**SUBJECT: INTERIM STORAGE PARTNERS' LICENSE APPLICATION TO CONSTRUCT
AND OPERATE THE WASTE CONTROL SPECIALISTS CONSOLIDATED
INTERIM STORAGE FACILITY, ANDREWS COUNTY, TEXAS, DOCKET NO.
72-1050 – FIRST REQUEST FOR ADDITIONAL INFORMATION, PART 1**

**First Request for Additional Information, Part 1 (non-proprietary)
Docket No. 72-1050**

WCS Consolidated Interim Storage Facility in Andrews County, Texas

Figure 2-3
Proposed WCS CISF 1-mile Radius

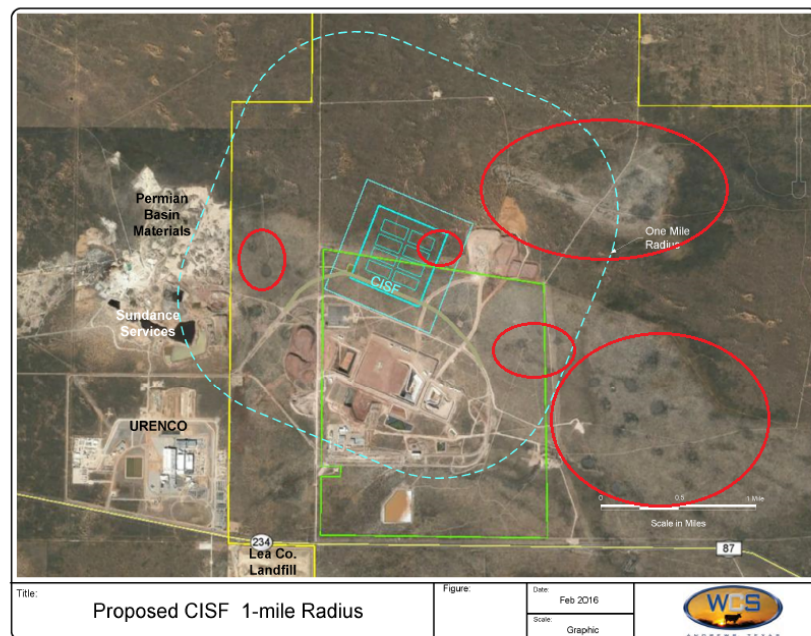
RAI 2.6-1 Clarify the origin of the circular features as identified in the red circles on Figure 2-3 below. Specifically, provide the dimensions of the features and determine whether they might represent surface deformation at the site due to subsurface dissolution resulting from past or ongoing natural processes or human activities

in the site area, as mentioned in WCS CISF SAR Section 2.6.1. Also, discuss the potential for similar features to develop at the site in the future.

WCS CISF SAR Section 2.6.1 states, “near-surface regional structural controls may be locally modified by differential subsidence related to groundwater dissolution of Permian salt deposits.” However, the SAR does not specify where these locally modified areas of differential subsidence are located relative to the proposed site. The NRC staff noted the history of oil and gas exploration and extraction activities in the site area and the presence of some features in SAR Figure 2-3 that are circular in shape (i.e., similar to sinkholes or swales), some of which are shallow depressions 2 to 7 feet in depth.
